Customer : CU-DAR001 Dart Helicopters Services	Drawing Name : BASKET LID ASSEMBLY
Job Number : 37513A	
Estimate Number : 10206	
P.O. Number :	Part Number : D2989041
This Issue : 2/20/2008 S.O. No. :	Drawing Number : D2989 UNDER REVIEW <i>FC 08 02 21</i>
Prsht Rev. : NC	Project Number : N/A
First Issue : / / Type : LARGE FAB ASSY	Drawing Revision : B
Previous Run : 37512A	Material :
Written By :	Due Date : 3/15/2008 Qty: 1 Um: Each
Checked & Approved By : <i>FC 08 02 21</i>	
Comment : Est Rev: Removed D2989-043 05-11-03 JLM

Drawing Name: BASKET LID ASSEMBLY

DESIGN DS	DRAWN BY PH	DART AEROSPACE LTD HAWKESBURY, ONTARIO, CANADA	
CHECKED <i>[Signature]</i>	APPROVED <i>[Signature]</i>	DRAWING NO. D2989	REV. B SHEET 1 OF 3
DATE 05.06.07		TITLE BASKET LID ASSEMBLY SCALE NTS	
A	00.10.27	NEW ISSUE	
B	05.06.07	ADD SHIM UNDER HINGES, UPDATE LID DIMENSIONS

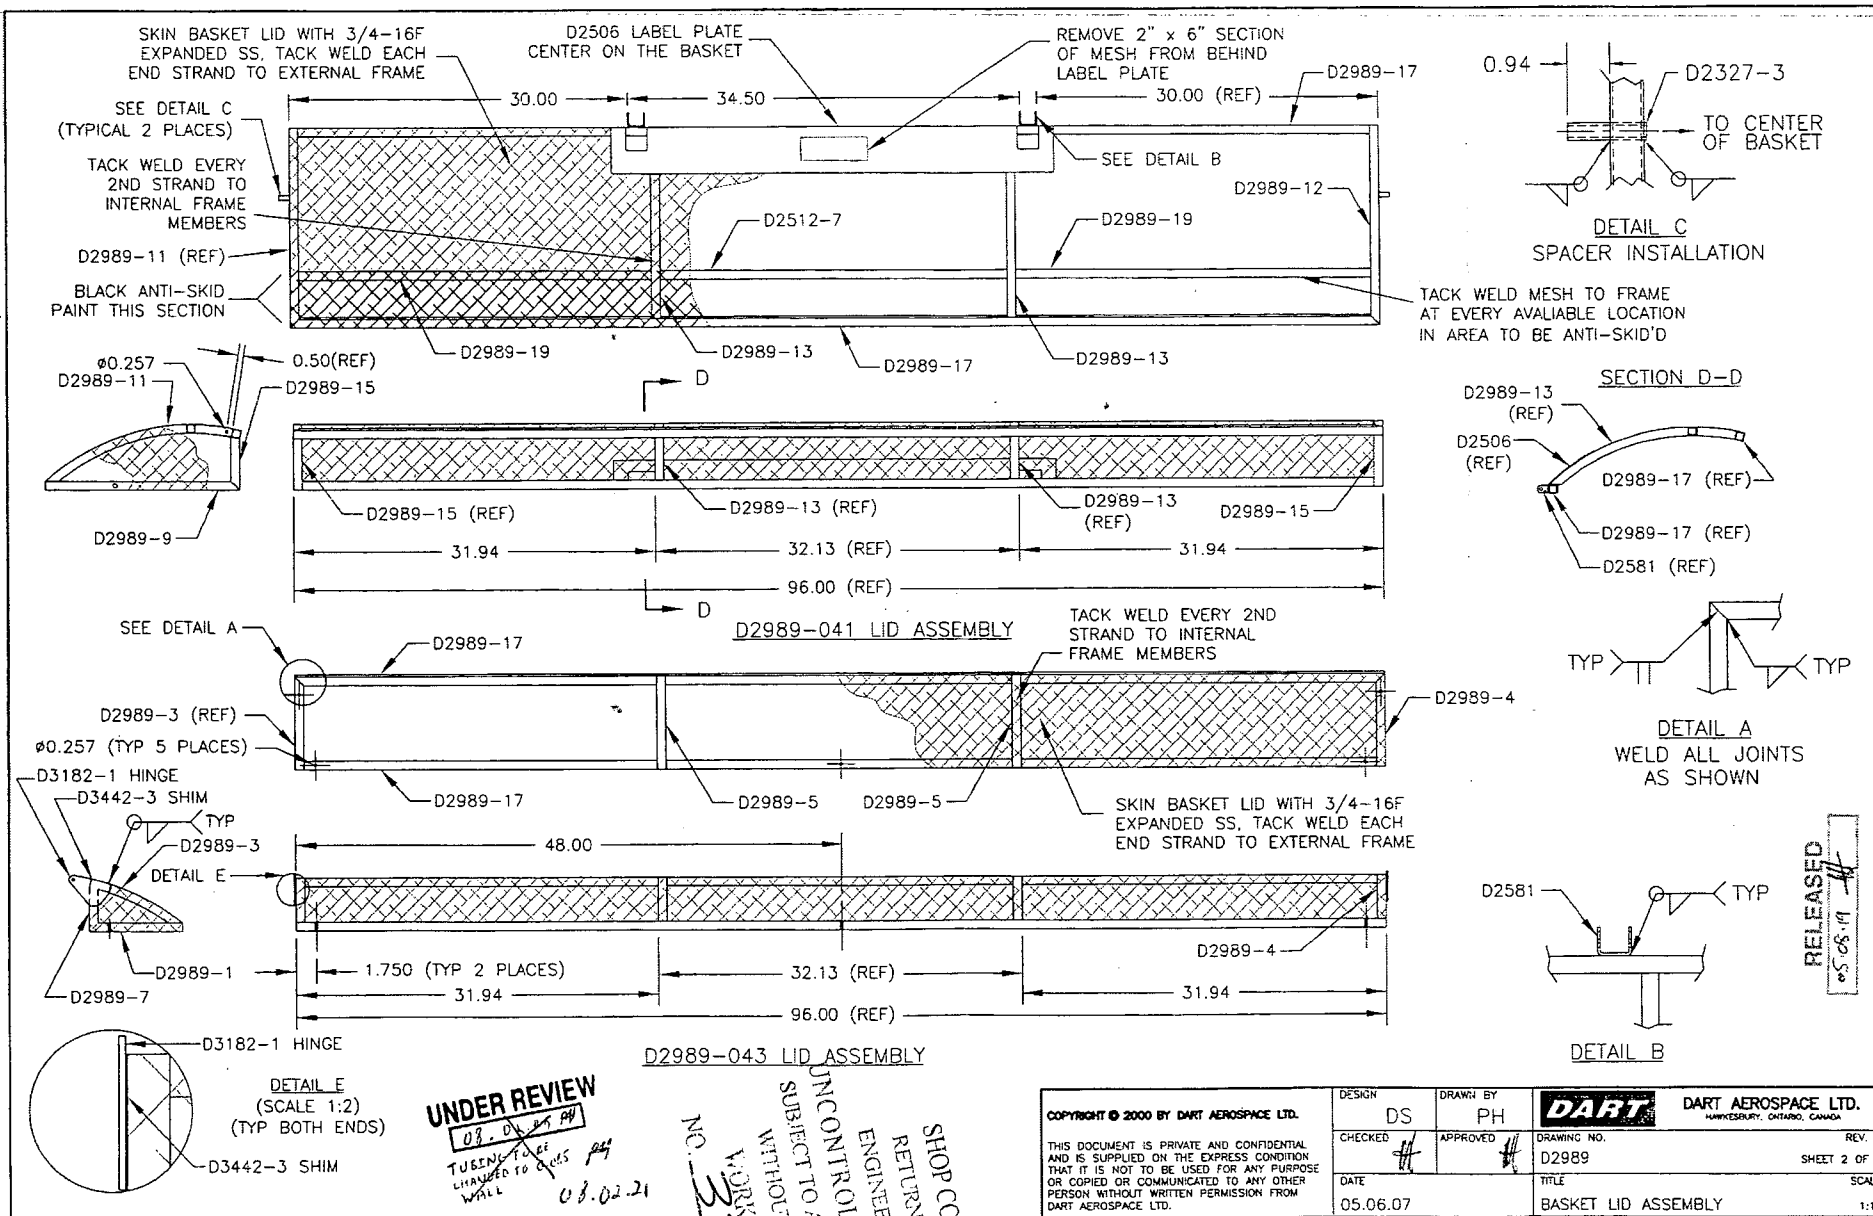
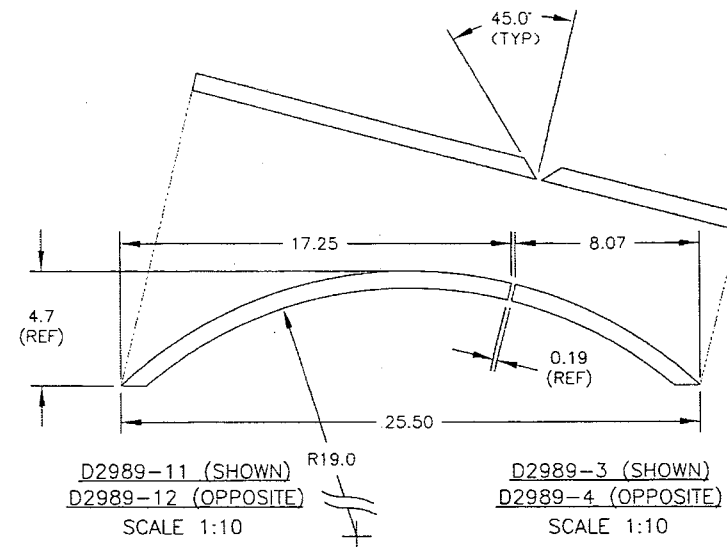
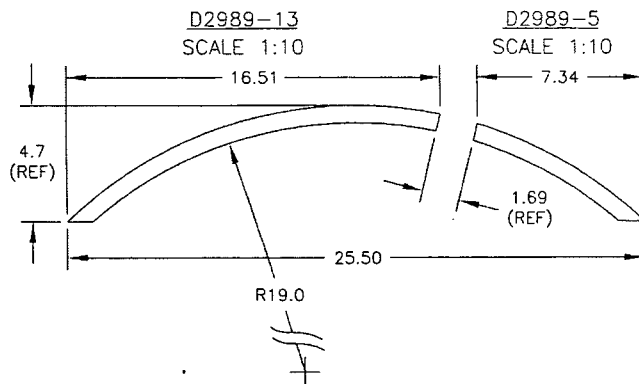
UNDER REVIEW
08.08.06 *[Signature]*TUBING TO BE
CHANGED TO 0.065
WALL *[Signature]*
03.02.21SHOP COPY
RETURN TO
ENGINEERING
UNCONTROLLED COPY
SUBJECT TO AMENDMENT
WITHOUT NOTICE
WORK ORDER
NO. 37513A

COPYRIGHT © 2000 BY DART AEROSPACE LTD.		DESIGN	DRAWN BY		DART AEROSPACE LTD. HAMMERSLEY, ONTARIO, CANADA
		DS	PH		
CHECKED	APPROVED	DRAWING NO.		REV. B	
		D2989		SHEET 3 OF 3	
DATE	TITLE		SCALE		
05.06.07	BASKET LID ASSEMBLY		1:10

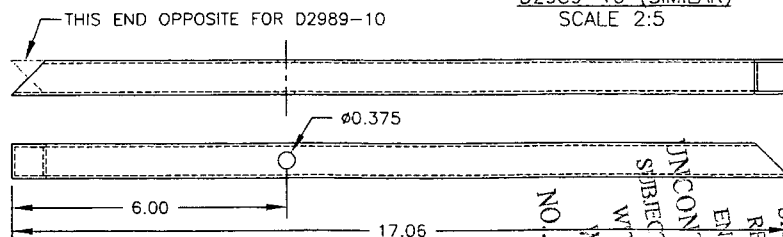
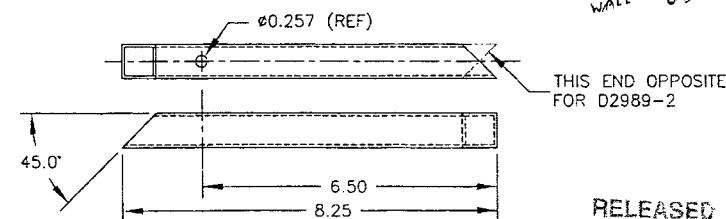
UNDER REVIEW
08.06.04
TUBING TO BE
CHANGED TO 0.05 PM
WALL 08.02.21
